Modification Recommended Service Note

M9155C PXI Hybrid Dual SPDT Coaxial Switch, DC to 26.5 GHz, Unterminated

Serial Numbers: TH60450001 – TH61350508

Solution/Action:

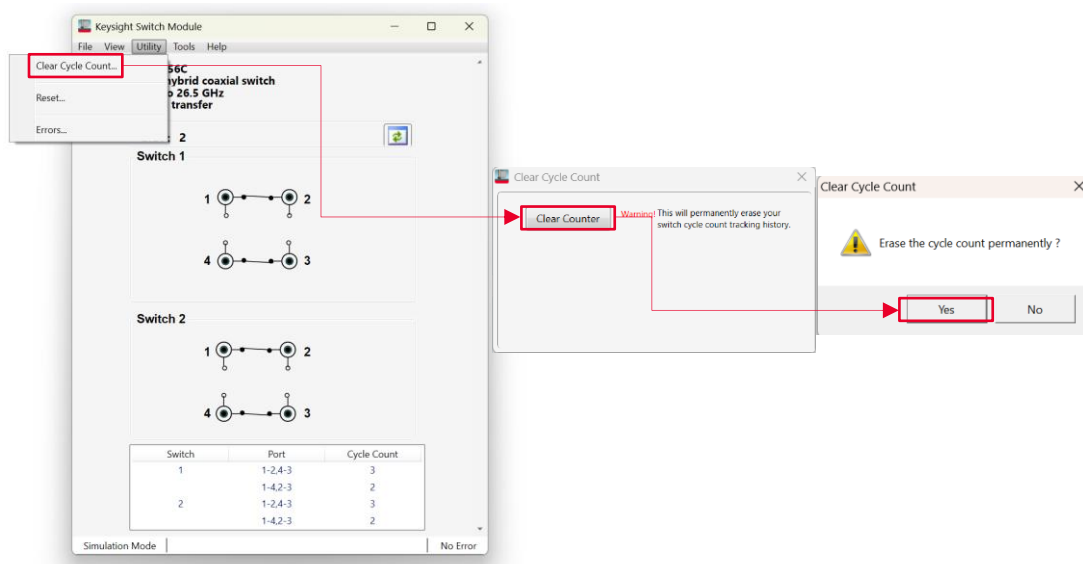
The cycle count of the unit is abnormally high. Fresh units from the factory have a cycle count of 16777215 cycles. This number is the default value for the EEPROM that stores the cycle count information. Due to a factory process issue, the cycle count was not reset. When users start using the switch, the cycle count starts from 16777215 onwards.

Clear the Cycle count using the Soft Front Panel (Keysight Switch Module)
Utility -> Clear Cycle Count -> Clear Counter -> Yes
